SEWAGE DISPOSAL SYSTEM

HOWARD COUNTY HEALTH DEPARTMENT
BUREAU OF ENVIRONMENTAL HEALTH
461-9933

REPAIR - TO ADJUST LOCATION OF INSTALLED SEPTIC SYSTEM. CALL FOR INSPECTION WHEN GROUND IS OPENED SO SANITARIAN CAN RECOMMEND REPAIR.

RE: The Heritage - Lot 42
Day Farm Road
Proposed Addition To Home
Infringing On Sewage
Disposal Easement

SITE PLAN SCALE 1" = 30'
 LOT 42 5TH ELECTION DISTRICT
 HOWARD COUNTY MARYLAND

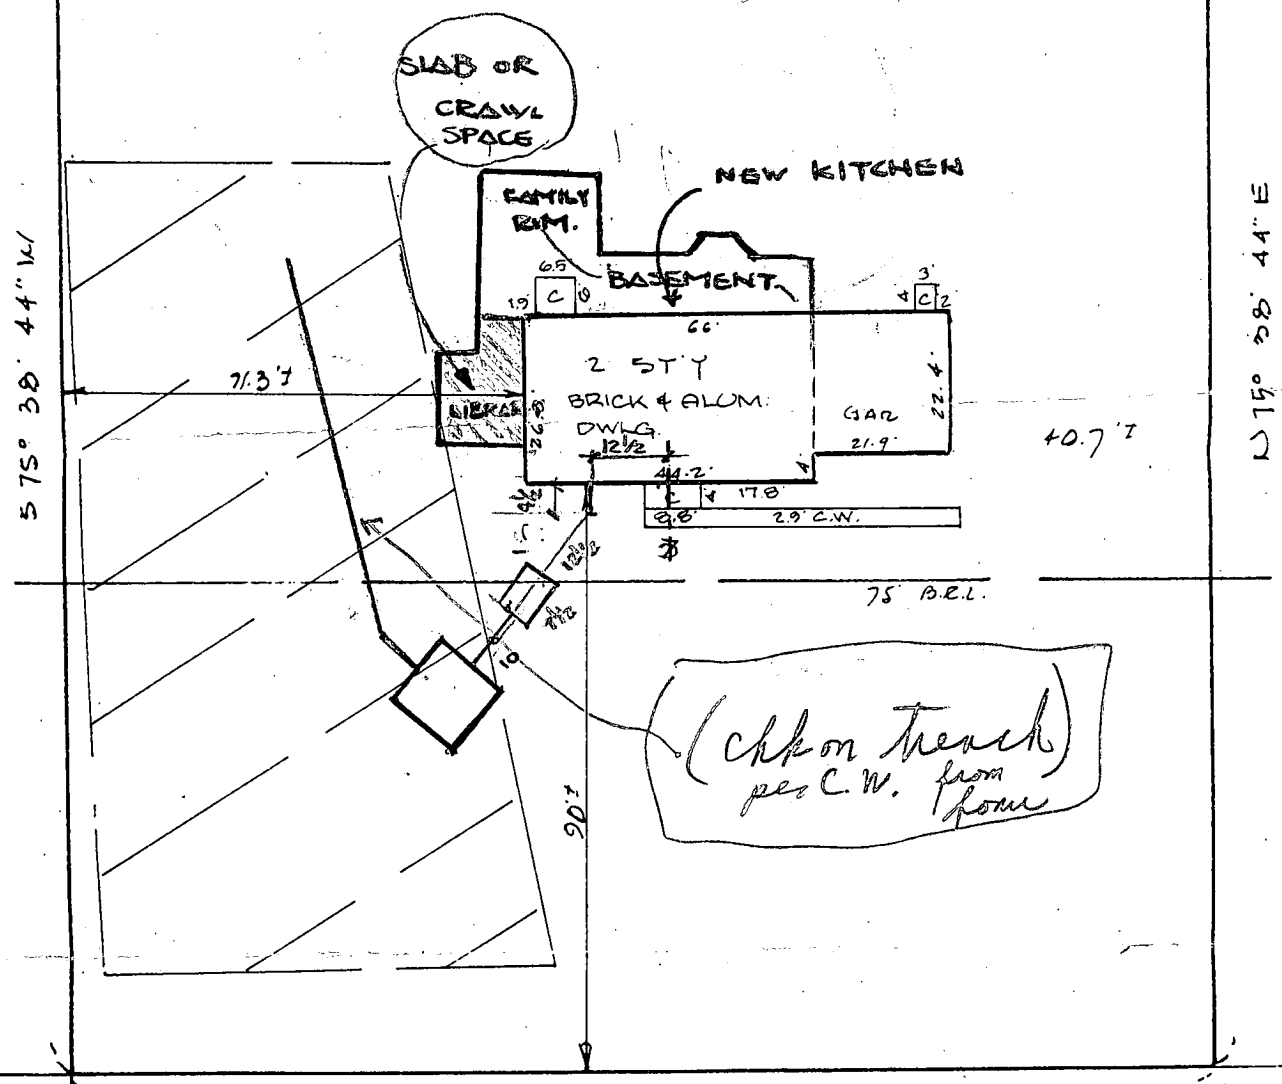
[B.M. TIC from Mr. C.W. Fyock's office]
Office 6/5/91 removing - upper trench // 40'± near house + to install trench
New trench 50 to 60' long at least 10'± downhill from existing trench which is being abandoned. Trench 2' wide, 2' deep, 9' deep, 7'± of stone - ok → C.B.O.

LOCATION DIAGRAM

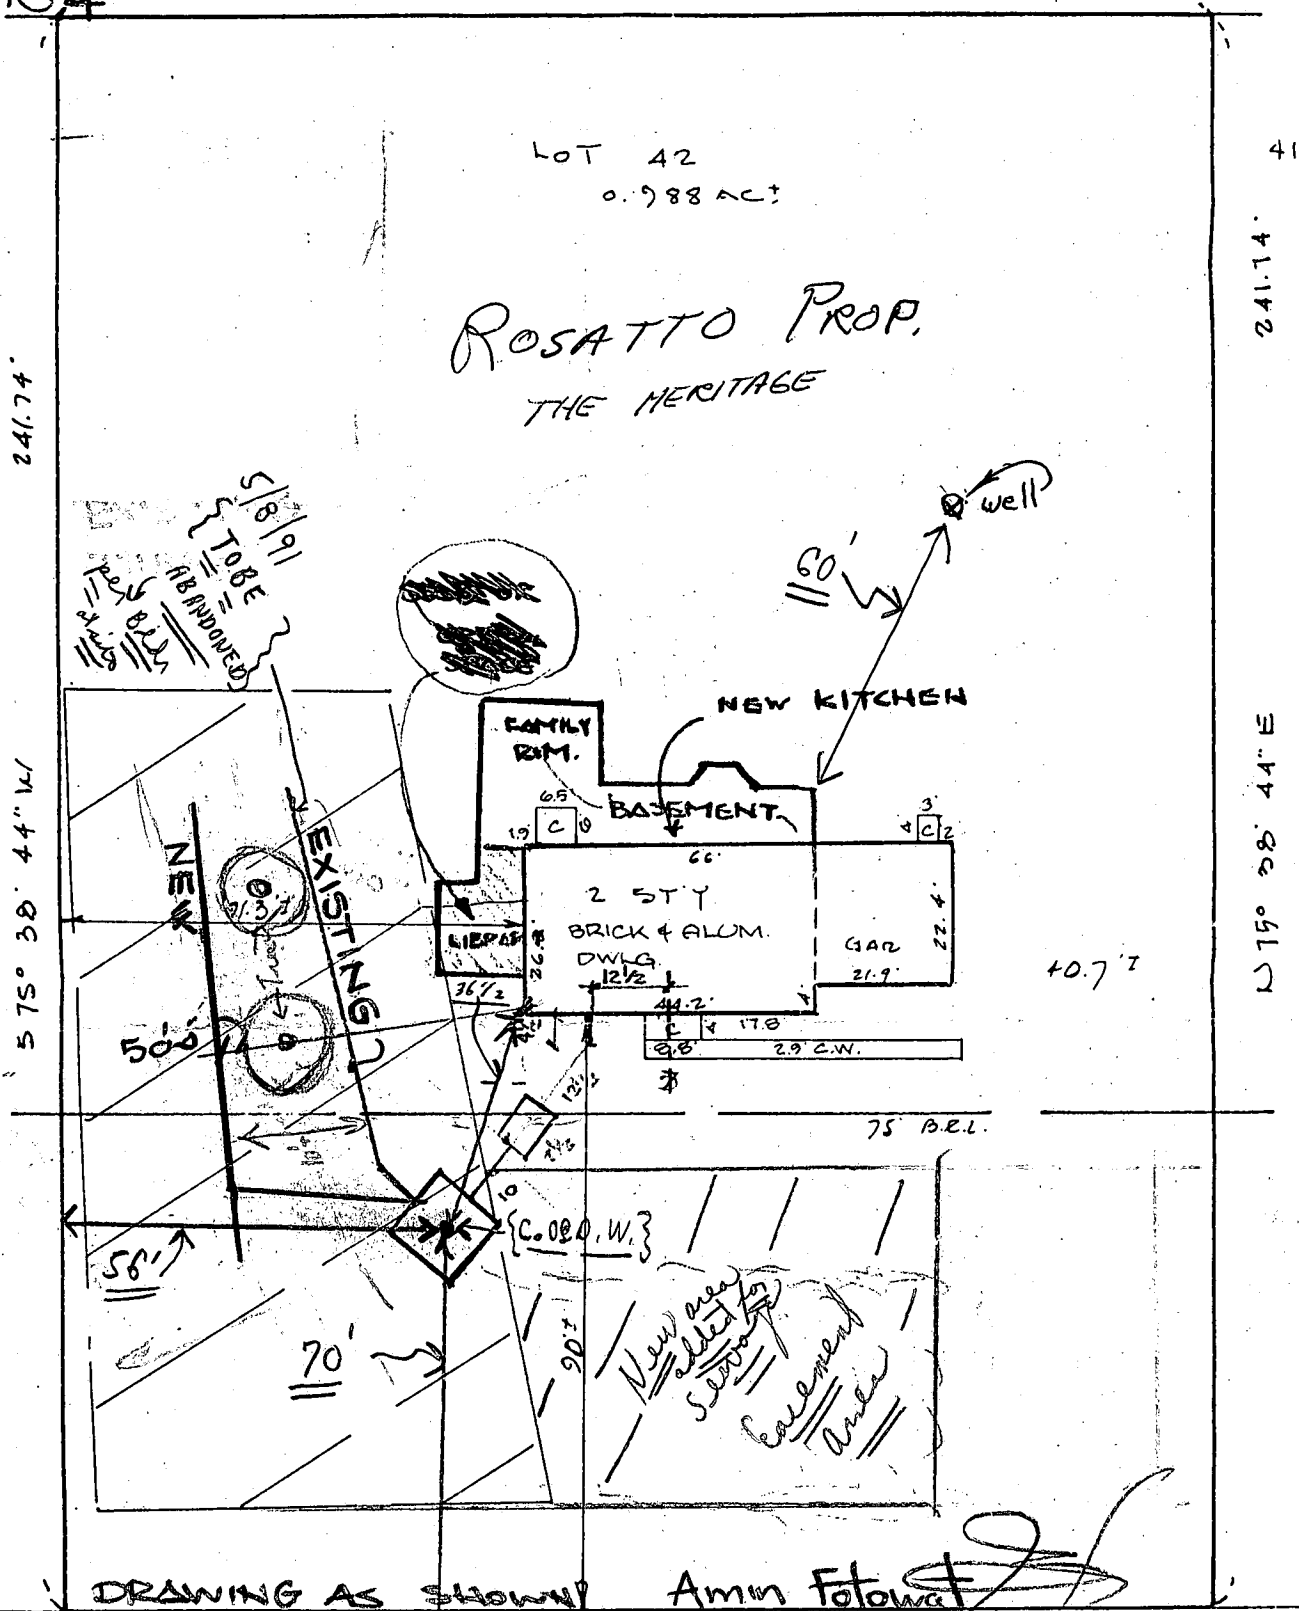
PROPOSAL: BUILDER WILL PROBE TO ESTABLISH TRENCH LOCATION RE: PROPOSED ADDITION,

(LETTER IN FILES SAYS ANY ADDITION INFRINGES ON SEPTIC AREA, HE INDICATES

I TOLD HIM IN CONFERENCE THAT IF ADDITION MAINTAINED 18-20' FLOOR ADDITION, THEN OK.)

Please see
updated
house site
plan attached
Received in field
A.M. of 5/8/91

COMMENTS: 5/8/91 See above & attached paper-

work. C.B.S. // ADDITIONAL REPAIR AREA WAS ESTABLISHED;

IF EXISTING TRENCH IS ABANDONED AND REPLACED, AND ADDITIONAL
REPAIR IS PLATTED, SUFFICIENT AREA WILL EXIST TO APPROVE THE ADDITION

**ON-SITE
GRAVING PLAN**

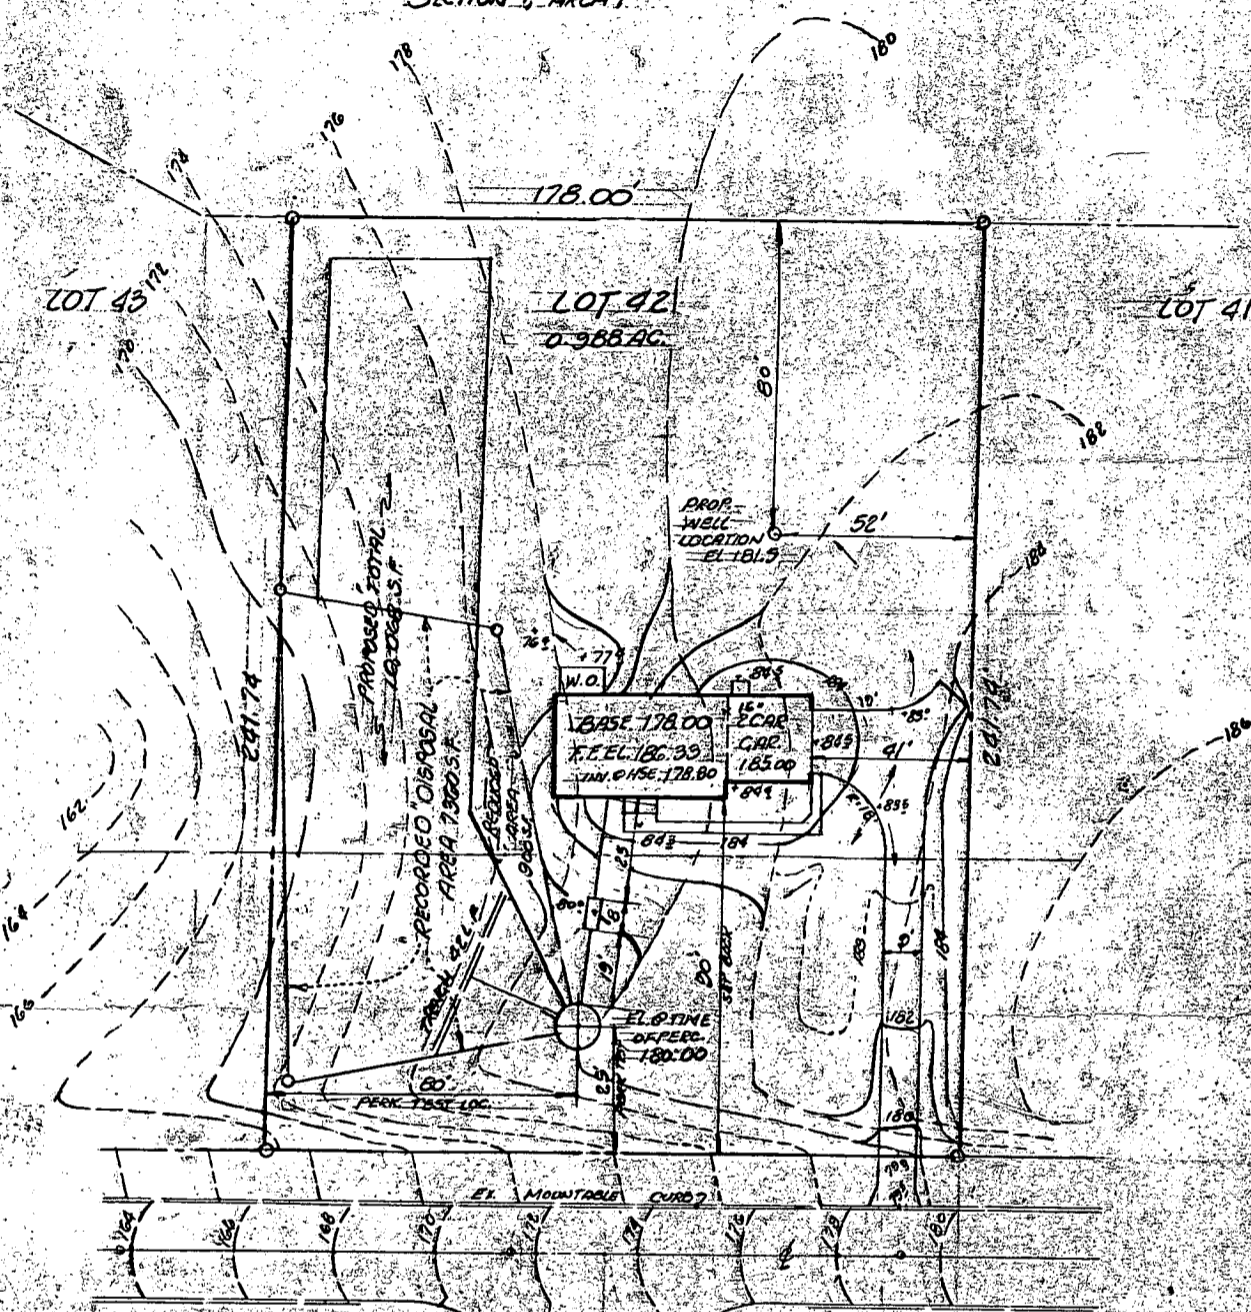
grading has
made these lots
restorable

Hold for review - report will be necessary on
this lot's at least visual hole on lots
43 & 44 (low lying).
